PLANNING APPLICATION PLN-21-0101

SMITH STREET, BETWEEN GEORGE STREET AND RECREATION GROUND, LONGFORD

Description of proposal: PLANT STREET TREES FROM 28-40 SMITH ST

Street Improvement Works (Street Trees, Medians)
STAGE 2 – FEBRUARY 2021
Smith Street Longford, Tasmania

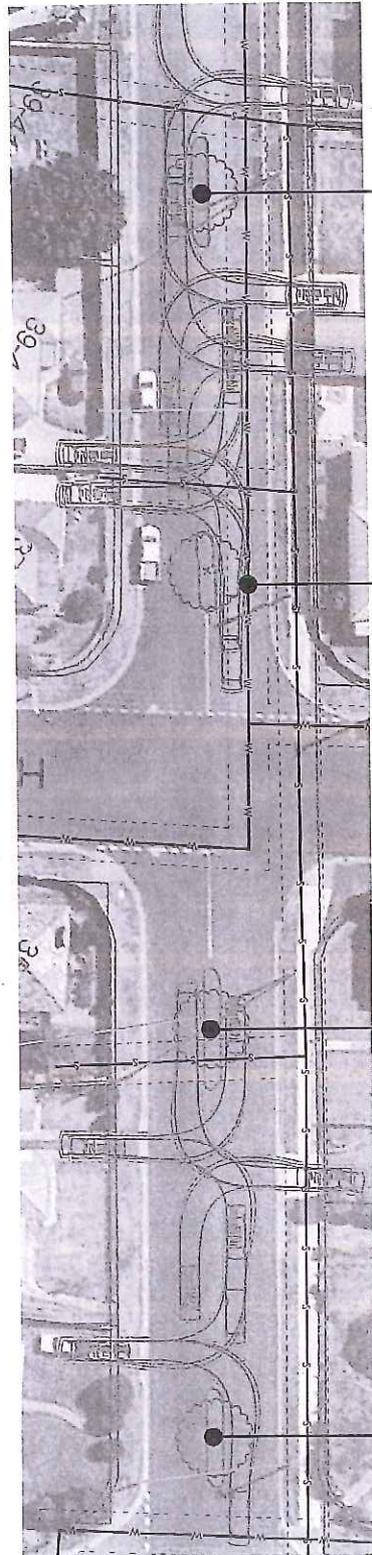
Whilst this implies tree positions have not been finalised, it is nevertheless concerning the indicated positions suggest multiple potential conflicts with TasWater and/or overhead infrastructure (see overlay plans supplied).

It would be remiss to suggest the proposal does not have potential to adversely impact on the traffic circulation, safety or network efficiency in the surrounding area and on this basis it seems reasonable to expect a Traffic Impact Assessment (TIA) be provided.

Due to deficiencies in the drawings, the included Traffic Comment' does appear capable of satisfying the requirements of a TIA.

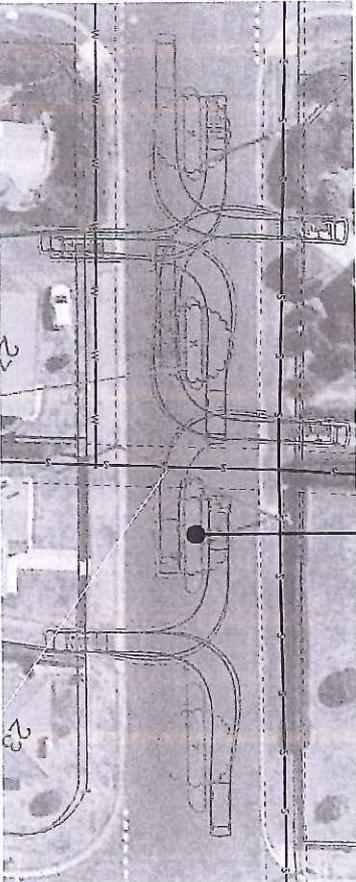
potential conflict with overhead wire

water pipe location in street may restrict access to one side for extended periods if repairs/maintenance required

potential conflict with overhead wire, proximity to sewer if tree position moved toward Howick St

HOWICK TO GODERICH

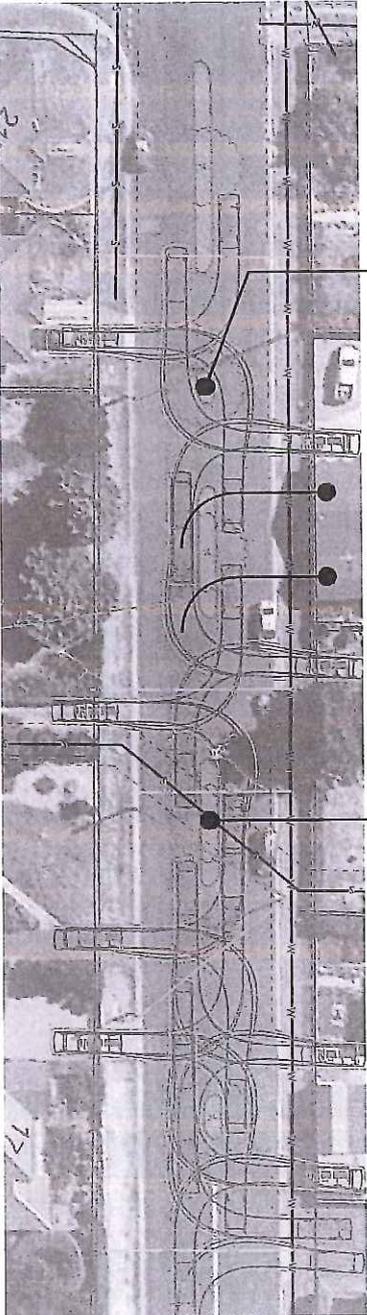
tree + general zone may prevent far side access to garages

potential conflict with sewer, overhead wire, no option for repositioning in zone due to water pipe

potential conflict with overhead wire
